Bulletin Number: DTB-052218

Date:May 22, 2018Product:Dunkirk Steam Boilers - ESC IV to ESC VFrom:Technical Service DepartmentTitle:ESC LWCO Probe Location Change

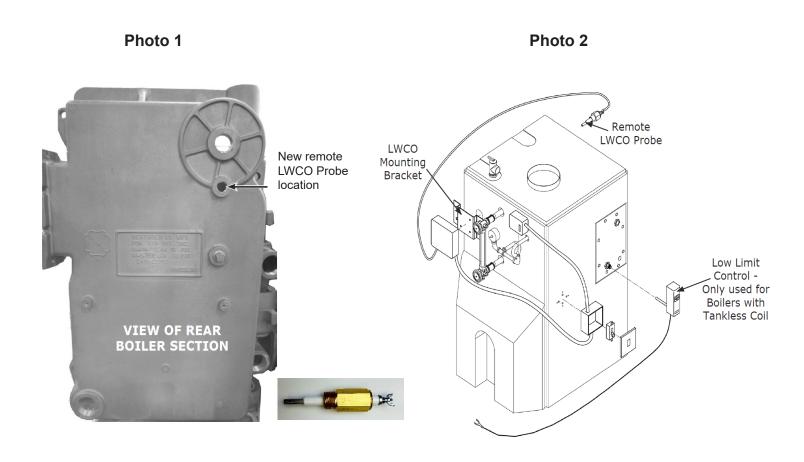
The current ESC IV oil fired steam boilers have the LWCO control and probe installed on the front section of the boiler. During steaming, the front of the boiler generates more steam than the rear of the boiler. This causes a density change. The less dense water in the front of the boiler is pushed higher by the denser water in the back of the boiler, causing a slightly slanted water line. The slanted water line has no effect on the boiler's ability to make dry steam. However, since the water line is slightly lower in the back section, it is logical to have the low water cut off monitor water level in the back section rather than the front section.

Dunkirk Boilers will be implementing a remote style LWCO sensing probe which will be in the back section of the casting. Locating the probe in the back section will provide the most accurate water level sensing.
